Groundwater Application Review Summary Form

Application # G- <u>19017</u>

PUBLIC INTEREST REVIEW FOR GROUNDWATER APPLICATIONS

TO:	Water Rights Section	Date <u>03/24/2023</u>
FROM:	Groundwater Section	Jen Woody
		Reviewer's Name
SUBJECT:	Application G- _19017 _	Supersedes review of 10/02/2020
	· · ·	Date of Review(s)

Hydrograph updated 3/24/2023:

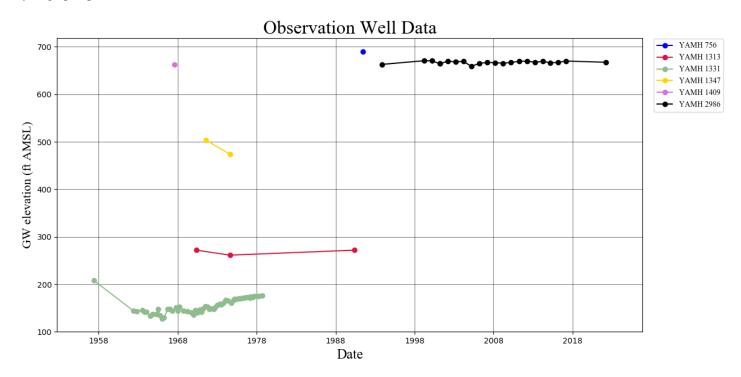
Nearby, long-term water level data are sparse. The nearest observation wells are located greater than a mile from the subject wells and show stable water levels over recent decades. There are no irrigation groundwater rights located within a mile. Domestic well density is also low within the general area but there are approximately 6 developed tax lots within ½ mile that are likely associated with houses that depend on domestic well water. Although the likely anisotropy of the aquifer makes it difficult to predict the potential for interference with existing wells, the general low yield of the aquifer indicates that it would be prudent to include water-level monitoring and water-use monitoring conditions.

Section B1a of this review was updated according to the Iverson (2023) memo. The water level data from nearby wells represents the same groundwater sources as the proposed use, represents current hydrologic conditions and established a sufficient interannual water level trend that does not meet the Division 8 definition of excessively declining or declined excessively (OAR 690-008-0001(4)(d)). Therefore the reviewer finds B1a " is not over appropriated".
